MIL "ON" DTC P0500

Section Engine Control

YEAR(S)	MODEL(S)	ADDITIONAL INFORMATION
2007 – 2009	Camry	Engine(s): 2AZ Transmission(s): 5AT VDS(s): BE46K

Figure 2. Location of Authorized Modifications Label on 2007 – 2009 Camry

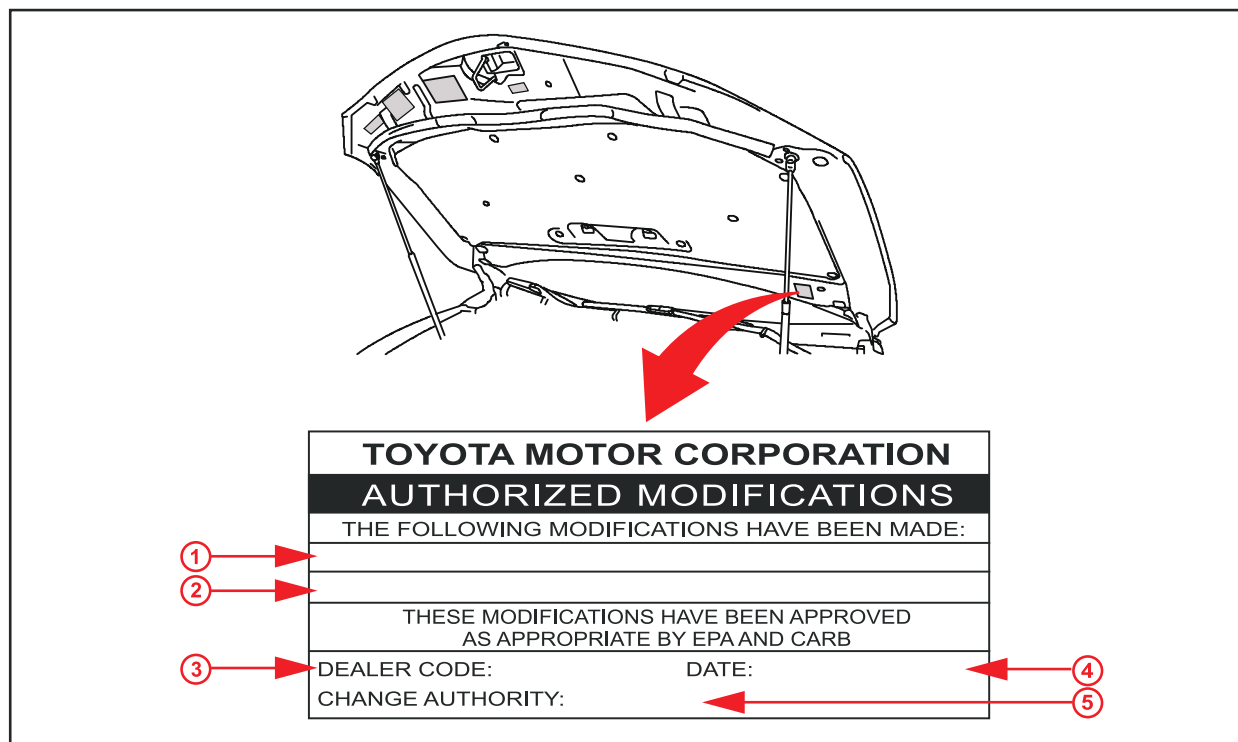
1. Check for the Authorized Modifications Label affixed to the vehicle in the location shown in Figure 2. Confirm if the ECM (PCM) calibration has been updated. If the calibration ID listed is NOT the latest ECM (PCM) calibration — go to step 2.

5. Install the Authorized Modifications Label.
 - A. Using a permanent marker, enter the following information on the label:
 - ECM part number [*Refer to the **Parts Information** section for the **CURRENT PART NUMBER***]
 - Calibration ID(s) [*Refer to the **Calibration Identification Chart** for the **NEW CALIBRATION ID***]
 - Dealer Code
 - Repair Date
 - Change Authority [***This TSB** number*]
 - B. Affix the Authorized Modifications Label to the vehicle at the location shown in Figure 2. The Authorized Modifications Label is available through the MDC, P/N 00451-00001-LBL.
